## Presentation to IPC Re Gunnedah Solar Farm

(first slide)

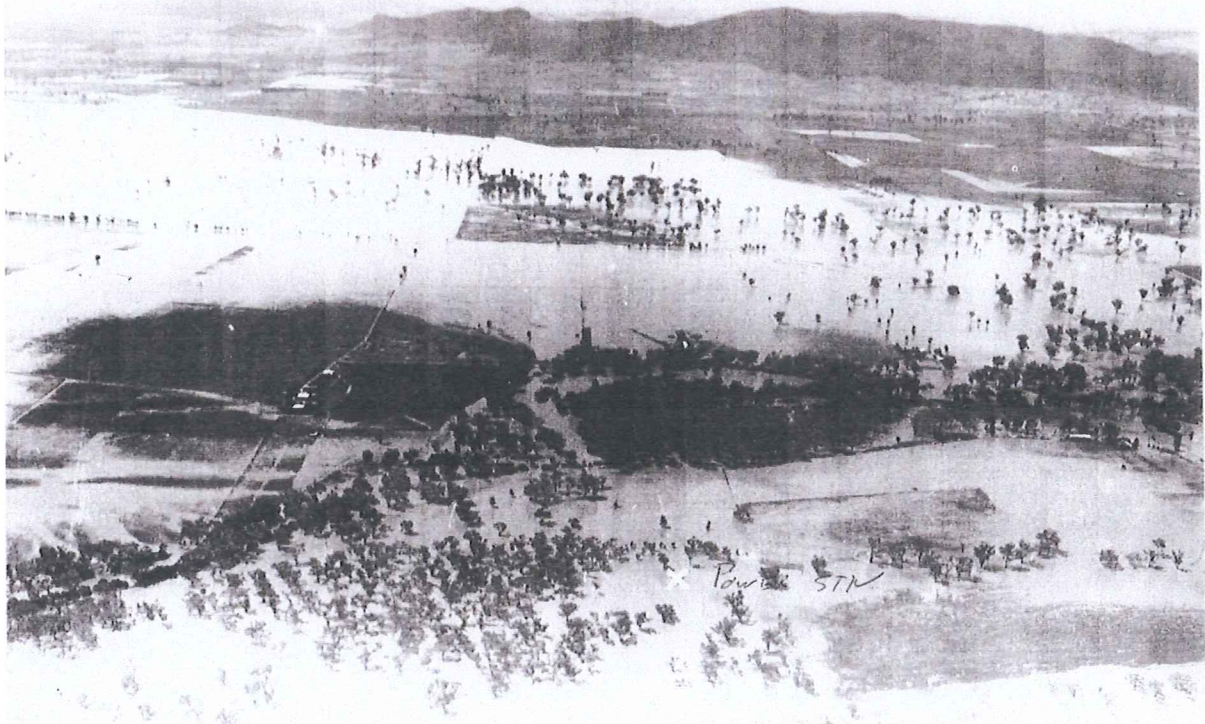
On page 14 it states that there are “no natural waterways” on the site. The Carroll to Boggabri flood study clearly shows a major discharge from the Namoi River on Galton’s property which heads straight through the proposed solar farm. Pitt and Sherry / Photon have definitely tried to address the flooding issue, and we have seen some improvements to the proposal. The fenced area has been moved back a little out of the deepest water, and there is now talk of flood fences. These adjustments are welcome, and an admission that there is a significant problem, but I do not believe that even yet they have a real understanding of the volume and speed of the discharge from the river, the size of which we hope to show the panel tomorrow.

This slide shows the flows of water across the floodplain during the 1955 flood, taken from the Carroll to Boggabri Floodplain study. It shows  $2.511 \text{ m}^3/\text{sec}$  passing by Carroll, and a major split at Galton’s property, across from the Solar Farm proposed site. (see green line heading north from the red dot).  $1.276 \text{ m}^3/\text{sec}$  passes over the farm, and only  $1.2401 \text{ m}^3/\text{sec}$  continues on down the river.

(next slide)

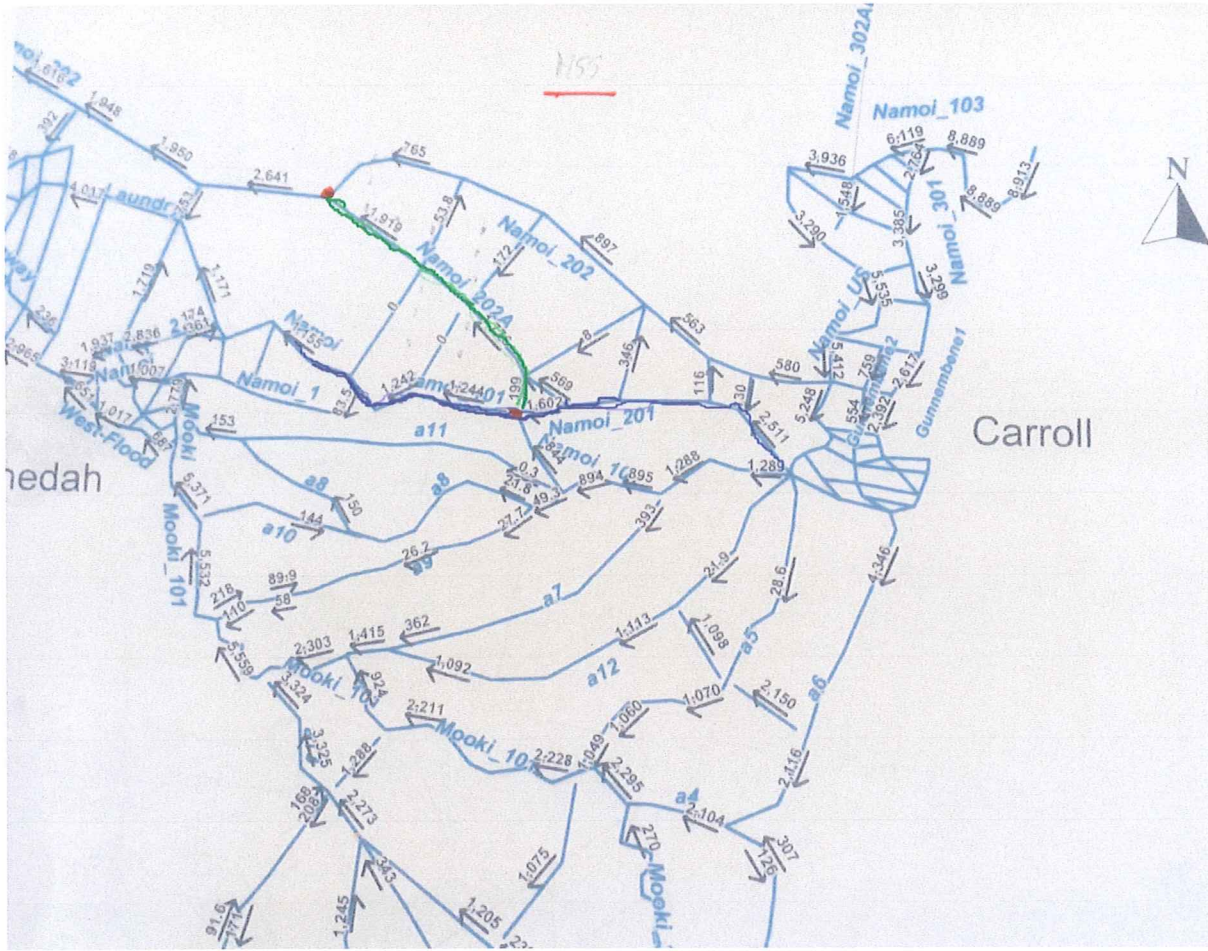
I would suggest some automatic electric mechanism be designed and tested and if successful used to drop all the panels simultaneously when the flood watch for the Peel / Namoi is issued. To manually drop this fence .... probably 2-3 km of fencing it would require a team of workers and 4 WD s to get it down as the flood is approaching and there could be real danger that they may be trapped at the site for the duration of the flood and not complete the job. My understanding is that there would be at most 2-3 people employed during the operation phase of this project – I question whether this would be enough at short notice.

There needs to be a proper plan for dropping the fence with strict protocols in place to make sure it will be done in a timely manner. Approval for this project should not be given until there are iron clad guarantees for a safe and acceptable design and operational procedures in place.
